# CITY OF TAMPA

## ADDENDUM NO. 1

12-C-00058; Channel District: 12th Street Wastewater Pump Station Improvements - **Rebid**

**CHANNEL DISTRICT  
12TH STREET PUMP STATION**

| SHEET E-1/016       |           |

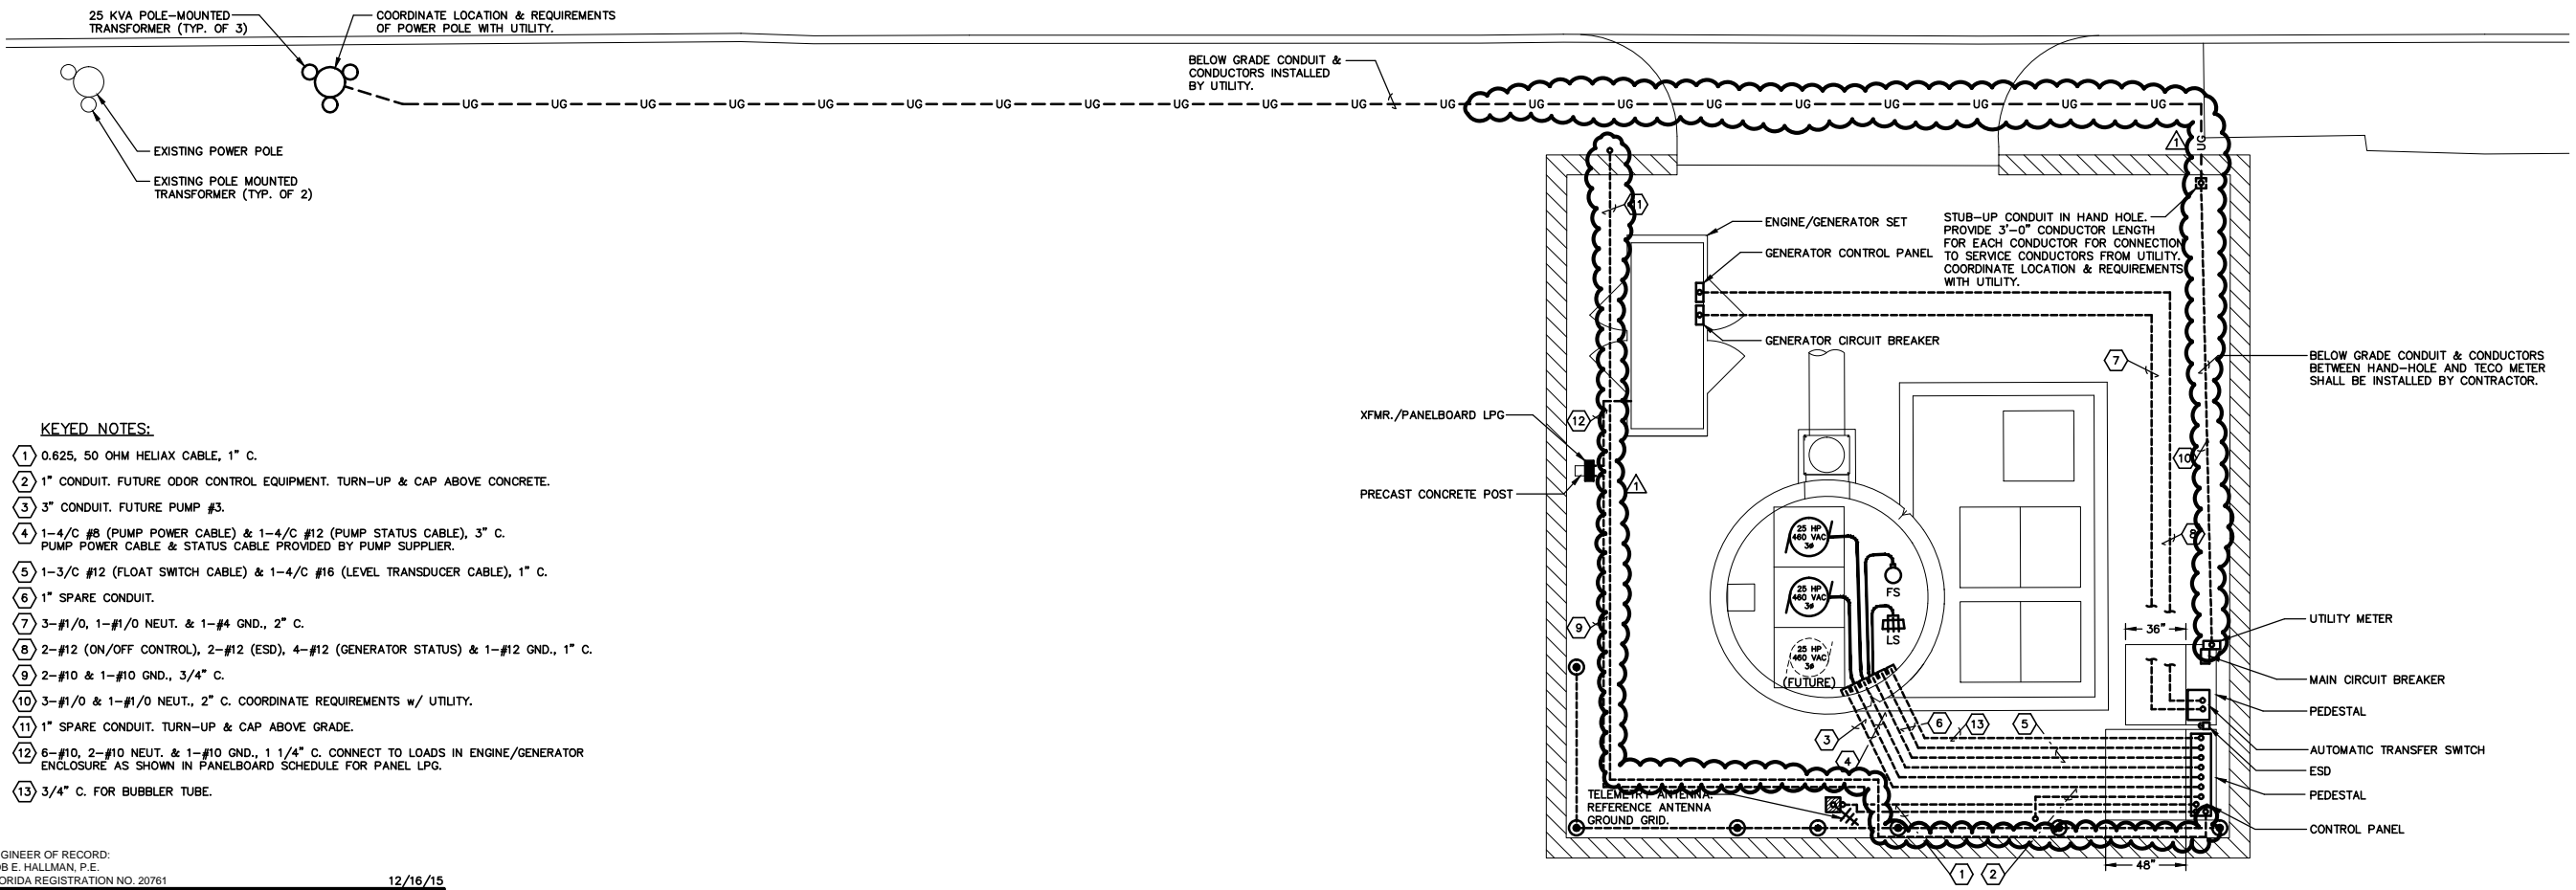
- Item 1: Specifications: Previous Bid Addenda 2 through 5 are inserted in the front of the Specifications for inclusion as part of the Bid/Contract Documents. The Re-bid Specifications have been conformed to previously issued Addendum 1.
- Item 2: Plans, Sheet No. 015 – Miscellaneous Details, Chain Link Fence Gate: **REPLACE** Sheet No. 015 – Miscellaneous Details with attached Sheet No. 015 indicated to have Revision No. 3 (dated 01/22/2016) for added black vinyl coating. **PROVIDE** black vinyl coating equal to Class 2B, thermally fused and bonded on minimum 9 GA core wire fabric, posts, etc.
- Item 3: Plans, Sheet No. E-1 – Electrical Site Plan: **REPLACE** Sheet No. E-1 – Electrical Site Plan with the attached Sheet No. E-1 indicated to have Revision No. 1 (dated 12/16/15) to re-route conduits.
